Sub: Modification Sheet No. RDSO/2025/EL/MS/0507, Rev. '0' Dated 25.02.2025

Modification Sheet No. RDSO/2025/EL/MS/0507, Rev. '0' Dated 25.02.2025

Provision of Waterless Urinal in WAG-9/9H/9HC 3-phase electric locomotives.

Proposed Location of Water-less Urinal

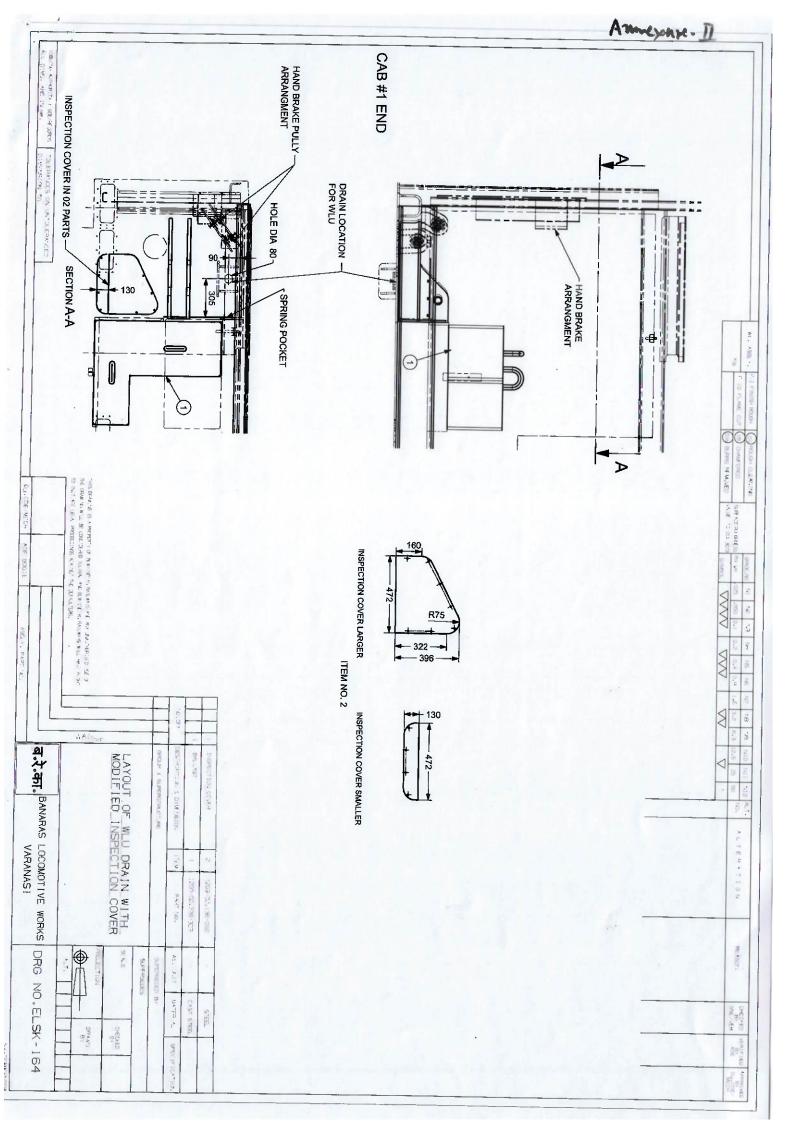
Waterless urinal (WLU) shall be mounted in the available space between ballast and CO2 cylinder on WLU assembly mounting frame. (Annexure -I).

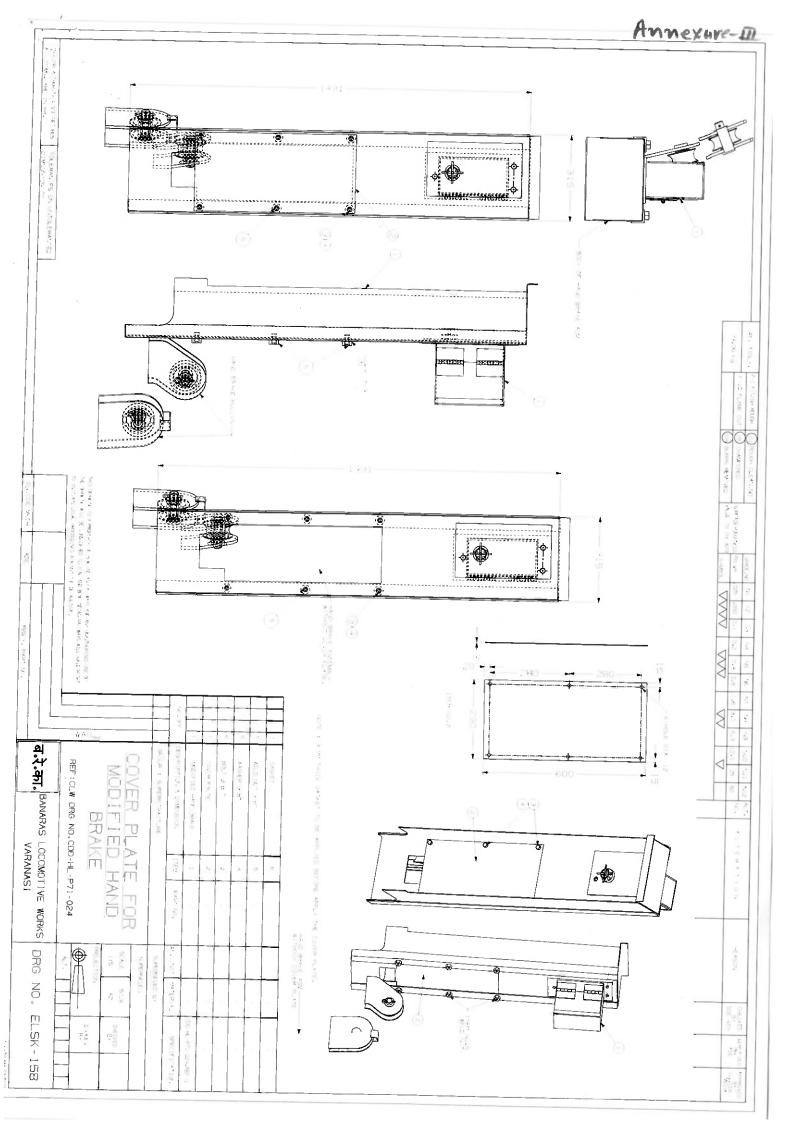
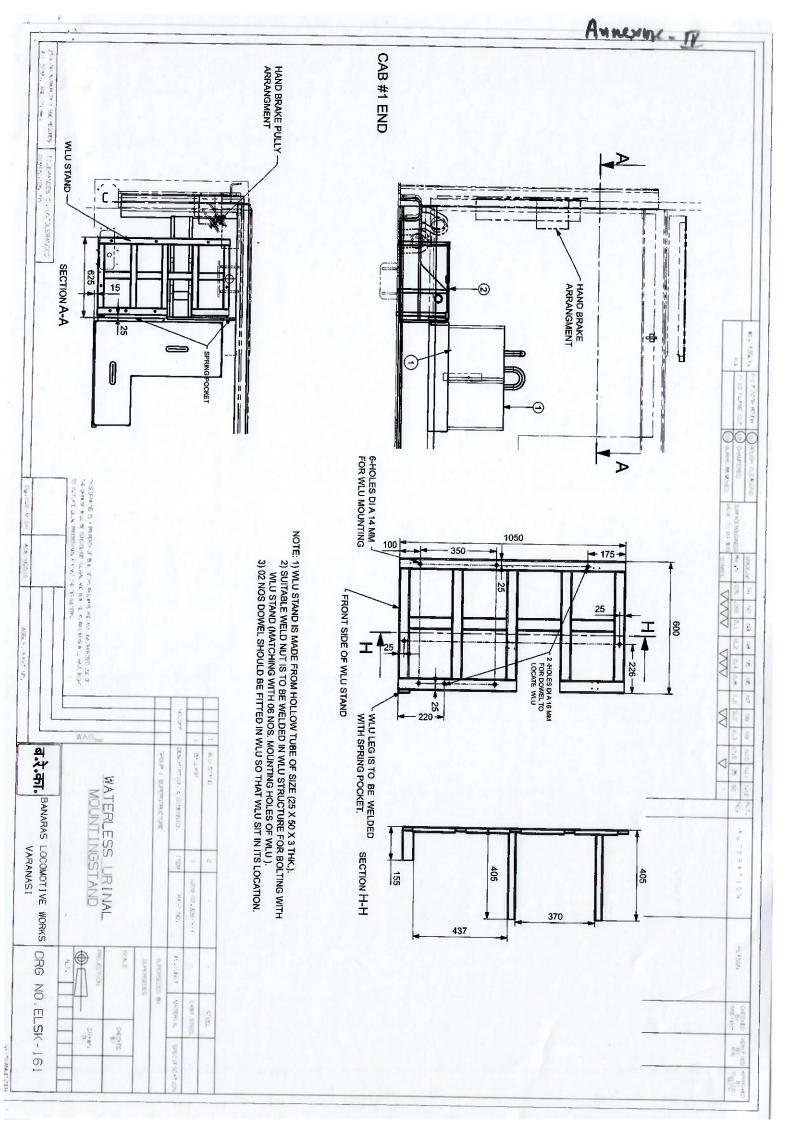
The TM plenum ventilation inspection cover shall be modified as per BLW drawing no. ELSK- 164 (Annexure-II) to enable the inspection of ventilation duct after installation of waterless urinal.

Rear wall of hand brake assembly shall be cut and covered with openable plate with bolted arrangement from the cab side as per BLW drawing no. ELSK- 158 (Annexure -III) to enable the maintenance of hand brake assembly.

The drain arrangement of waterless urinal shall be as per BLW drawing no. ELSK- 164 (Annexure -II). PUs may incorporate this hole to the part of shell drawing to avoid making hole during fitment of WLU.

The Waterless urinal MS mounting stand shall be as per BLW drawing no. ELSK 161 (Annexure –IV).
